**Development Application DA2019/0081  
Supplementary Statement of Environmental Effects  
Amended plans and associated clause 4.6 variation request – Height of  
buildings  
Construction of residential accommodation  
12 Boyle Street and 307 Sydney Road, Balgowlah**

Reference is made to Council's correspondence of 4<sup>th</sup> July 2019 pertaining to the above matter. This submission details the considered response to the issues raised and is to be read in conjunction with the following accompanying documentation:

**VIEW ANALYSIS FROM 10 BOYLE STREET LEVEL G W3**  
 Sun Property Group  
 PROJECT ADDRESS  
 307 Sydney Road and 10 Boyle Street, Balgownie  
 SCALE 1:500  
 DATE 24/07/09  
 DRAWN BY ID:041  
 CHECKED BY JH  
 REF NO. 307 SRD  
 DRAWING NO. A-700  
 REV. A

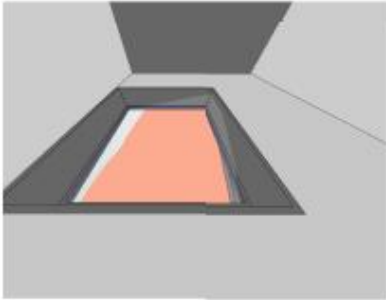
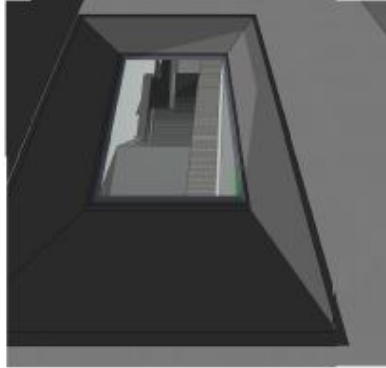
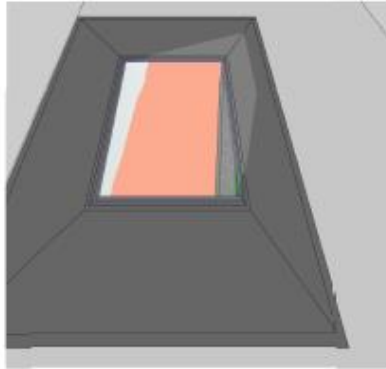
Comment: The extent of view impact is depicted on plans A700(A) to A705(A) with existing views available in an easterly direction across the rear portion of the subject site totally obscured from both bedroom windows at both ground and first floor level.

That said, oblique views obtained from these windows are maintained to varying extent such that at no location are 100% of available views obscured. Scenic distant harbour views from both bedrooms on level 2 are unaffected.

Bedroom View Analysis  
From Unit 4/16 Boyle St

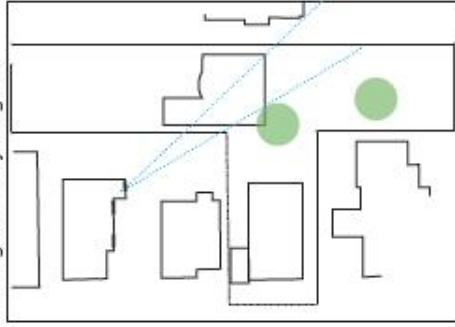
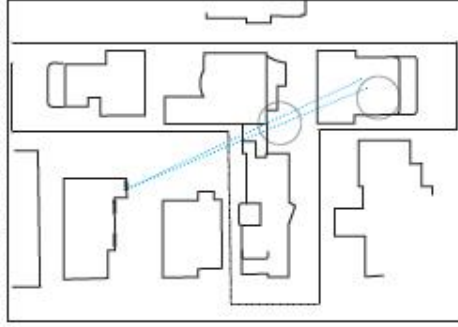
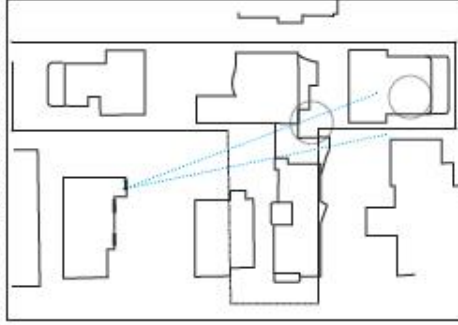
Comment: The view analysis prepared by Roberts Day Architects confirms that the amended scheme will totally obstruct the restricted, partial and filtered view available in a south easterly direction from the south facing bedroom window towards the eastern tip of Dobroyd Head and the ocean horizon beyond however will create a new view corridor in a southerly direction incorporating a restricted and partial view towards Dobroyd Head and its ridgeline.

In this regard, a number of options were considered to provide for the retention of some scenic views from this property whilst not significantly altering the design of the development or the agreed design parameters associated with the works proposed to the existing heritage item located on the subject property. It was ultimately determined that the removal of the existing vegetation at the rear of No. 12 Boyle Street coupled with the relocation of the western lift 3.2 metres to the west and a corresponding adjustment in the design and layout of Units 3 and 6 and adjacent circulation courtyard would preserve a view corridor from Unit 4/16 Boyle Street towards Dobroyd Head from a standing position in the western living room and the ocean horizon from a standing position in the western living room area. Views towards Dobroyd Head will also be maintained from a standing position from the south facing bedroom window.

Western Living Room View Analysis  
From Unit3/16 Boyle St

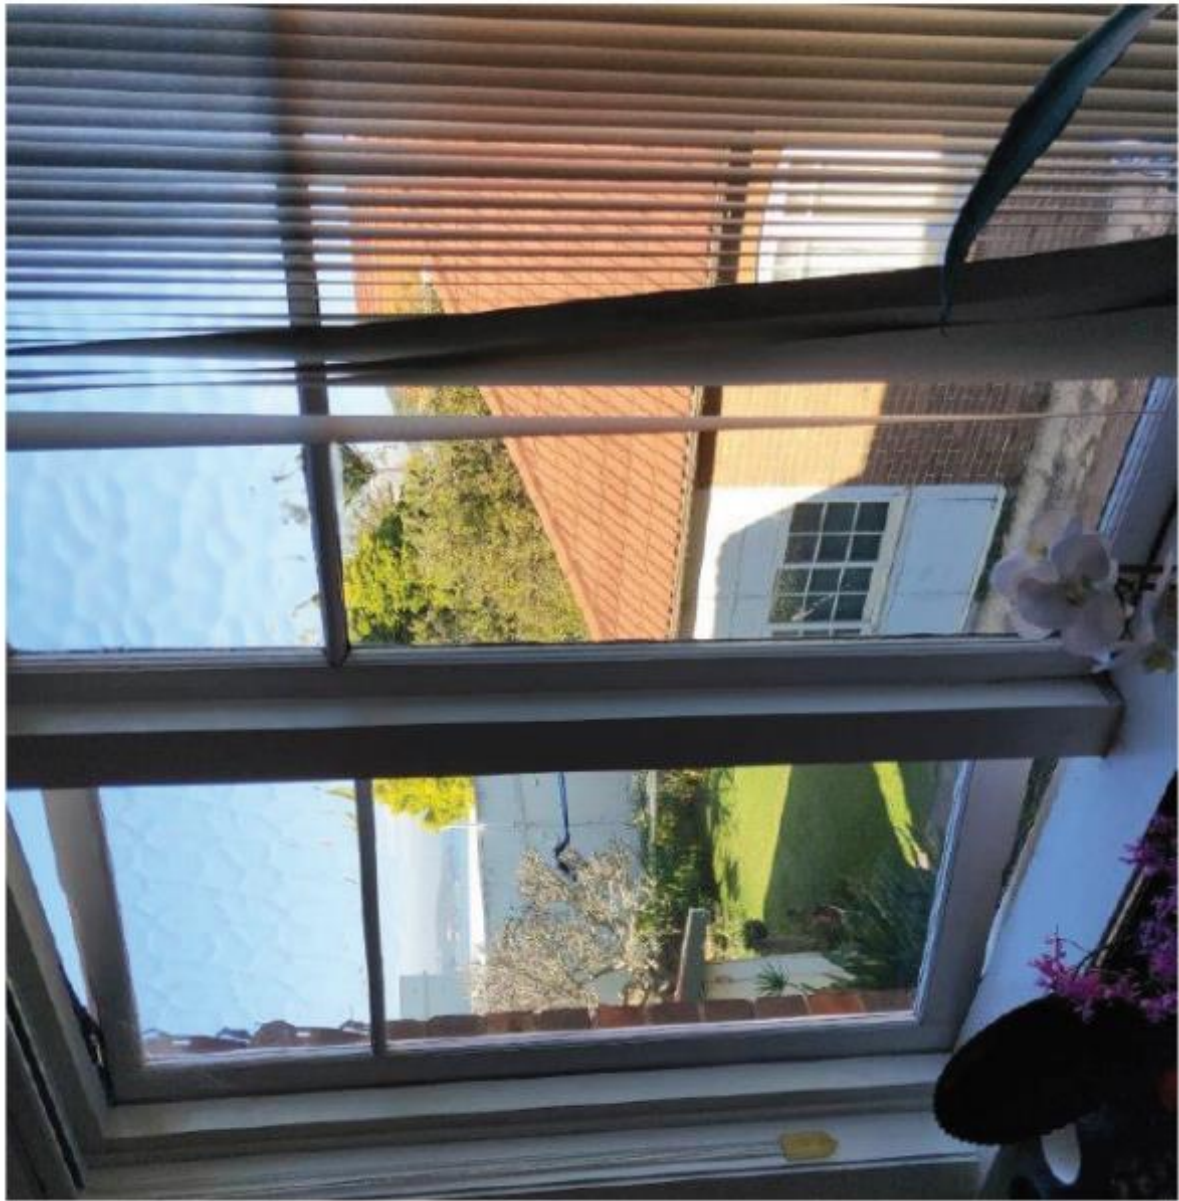
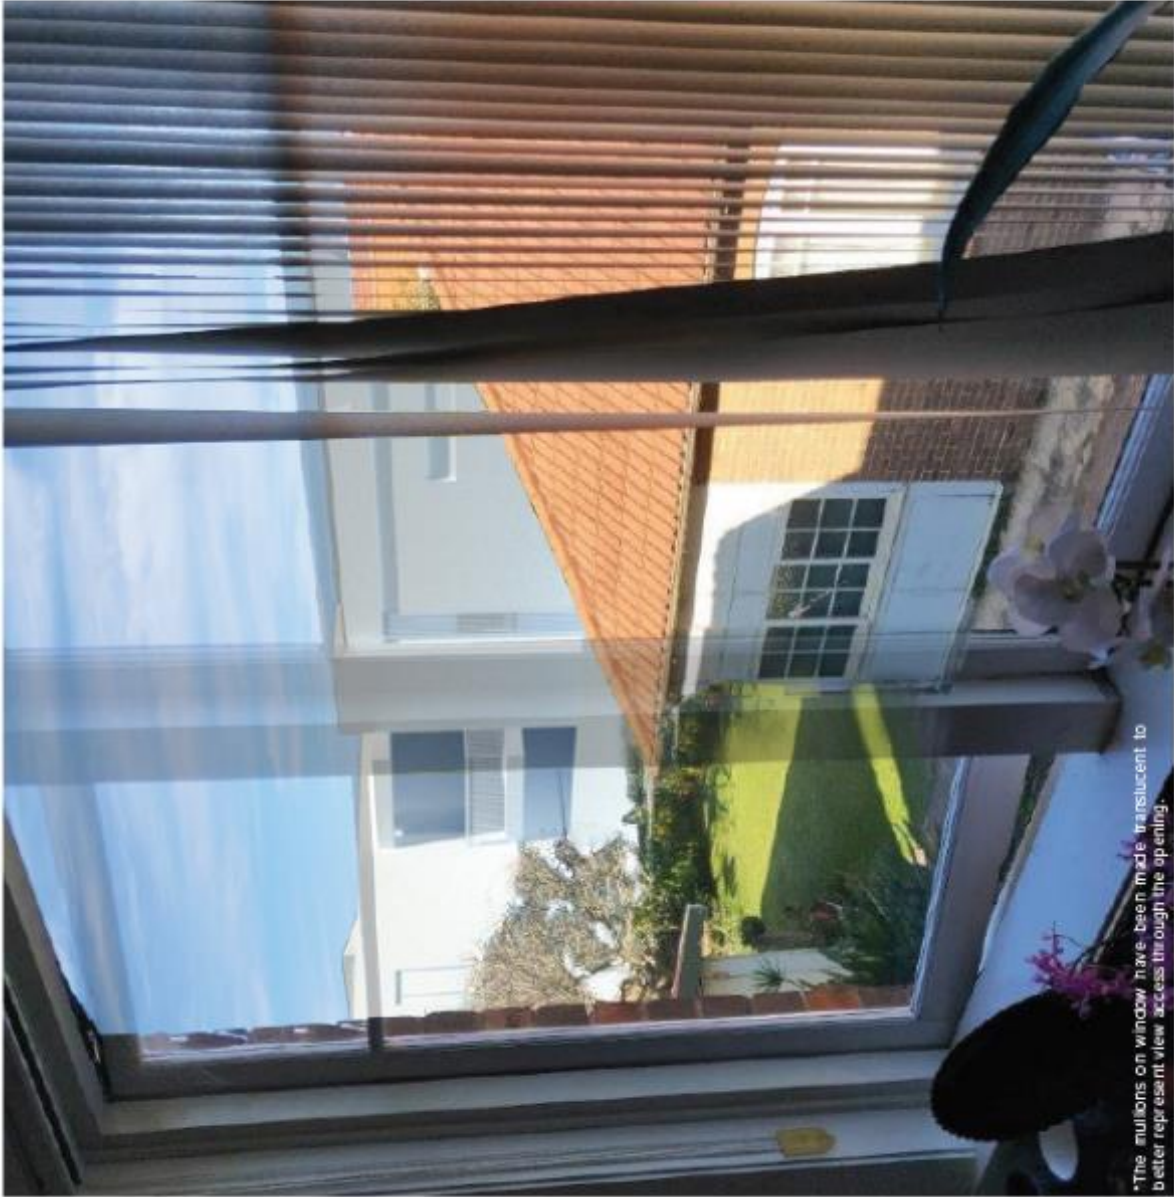
The amended scheme will totally obstruct the restricted, partial and filtered view available in a south easterly direction from the south facing western living room window towards North Head, its land/ water interface, Middle Harbour and the ocean horizon beyond however will maintain a restricted and partial ocean horizon view.
